# Work Order ID 89656

Item Name: Crosstube Assembly, Mid Fwd

| DRAWING NO.<br>D206-667-147 | TITLE<br>CROSSTUBE ASS'Y (206L MID FWD) | REV. A               | <b>DART AEROSPACE LTD<br/>ENGINEERING ORDER</b> |  | D.E.O. NO.<br>D206-667-147-A-1 | SHEET NO.<br>SHEET 1 OF 1 | SCALE<br>NTS |

| DRAWING NO.<br>D206-667-147 |  | TITLE<br>CROSSTUBE ASS'Y (206L MID FWD) |  | REV. A           |  | DART AEROSPACE LTD<br>ENGINEERING ORDER |  | D.E.O. NO.<br>D206-667-147-A-2 |  | SHEET NO.<br>SHEET 1 OF 1 |  | SCALE<br>NTS     |  |

**DETAIL P**  
BONDING STRAP INSTALLATION 2 PL

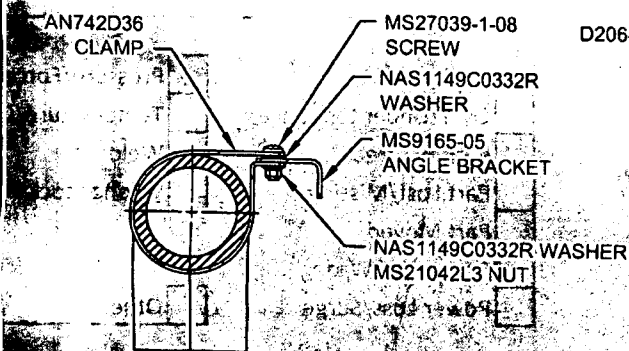
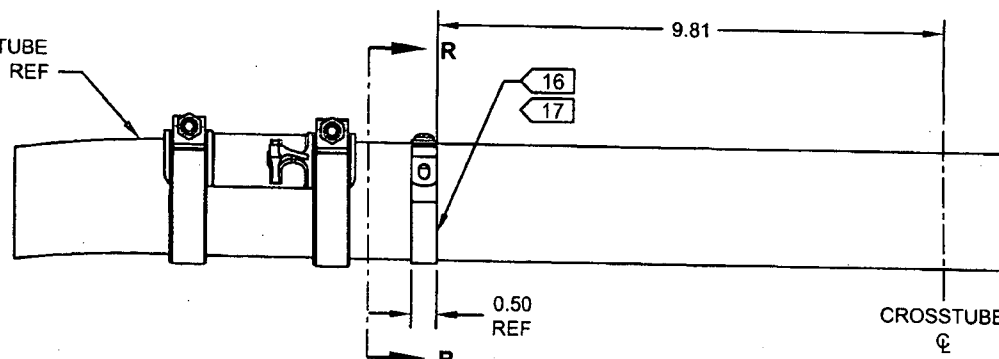
ADD ELECTRICAL GROUNDING STRAP

- 16) MASK AREA UNDER CLAMP PRIOR TO PAINTING
- 17) SEAL EDGES WHERE AN742D36 CLAMP MEETS WITH THE CROSSTUBE USING SIKAFLEX-241/-291 OR MIL-S-8802 CLASS B2 OR PROSEAL 890 SEALANT
- 18) PERFORM RESISTANCE CHECK TO ENSURE MAX RESISTANCE IS 10 MILLIOHMS
